REMARKS

Application No.: 10/700,481
Art Unit: 2877

Docket No.: 967.43262X00
Page 12

FIG. 1
 Prior Art

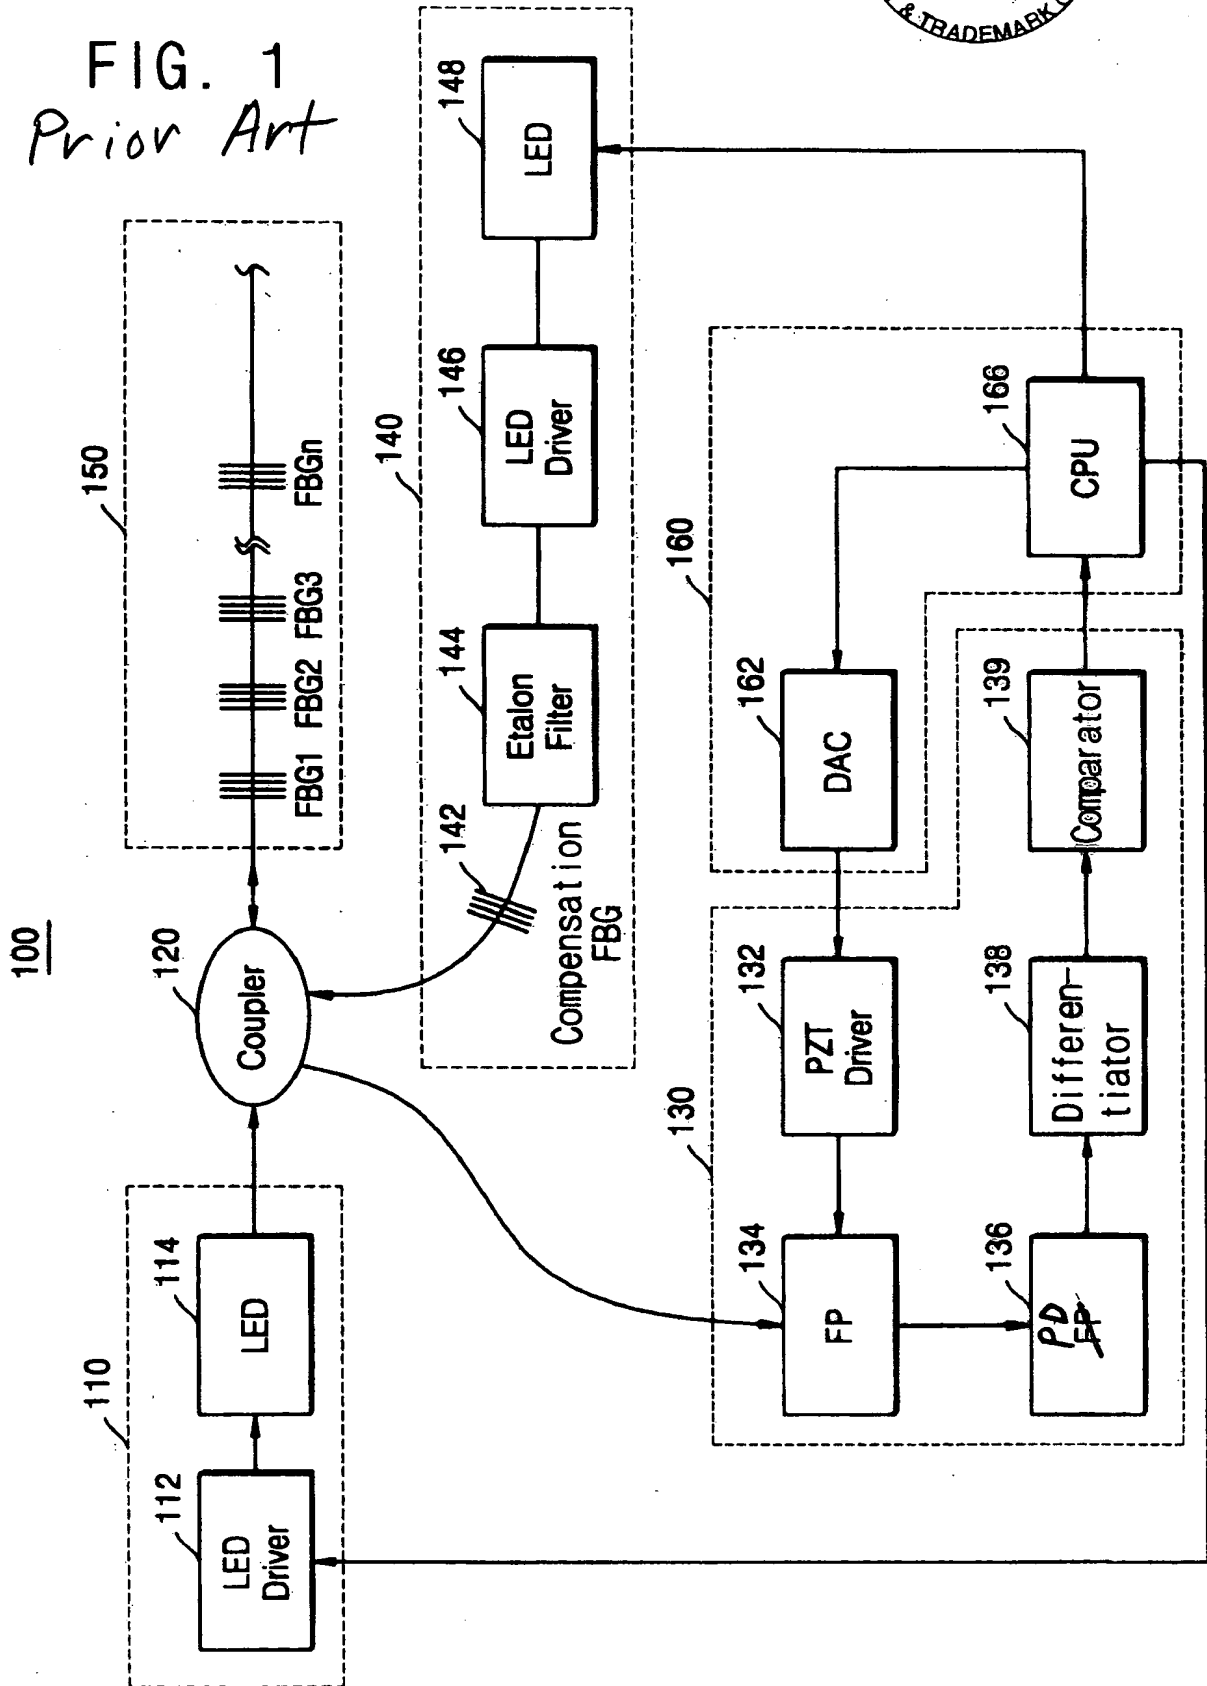
The attached sheets of drawing include changes to Figs. 1 and 2. These sheets, which include Figs. 1 and 2, replace the original sheets including Figs. 1 and 2. Both Figs. 1 and 2 have now been labeled as Prior Art, as required in the Office Action. Also, Fig. 1 has been amended to correct the labeling of Box 136 to indicate that this is a photo diode (PD) corresponding, for example, to the identification of the element 136 as a Photo Diode (PD) on page 2, line 19 of the specification. It is assumed that this is the element which was actually intended by the Office Action statement "the drawings are objected to because the element "EP" 130 in Fig. 1 should be changed to "PD."" With regard to this, it does not appear that there is actually any element labeled "EP" 130 in Fig. 1. Accordingly, it is Applicants' understanding that the element 136, previously labeled "FP" is what was actually intended on page 3, lines 1 and 2 of the Office Action.
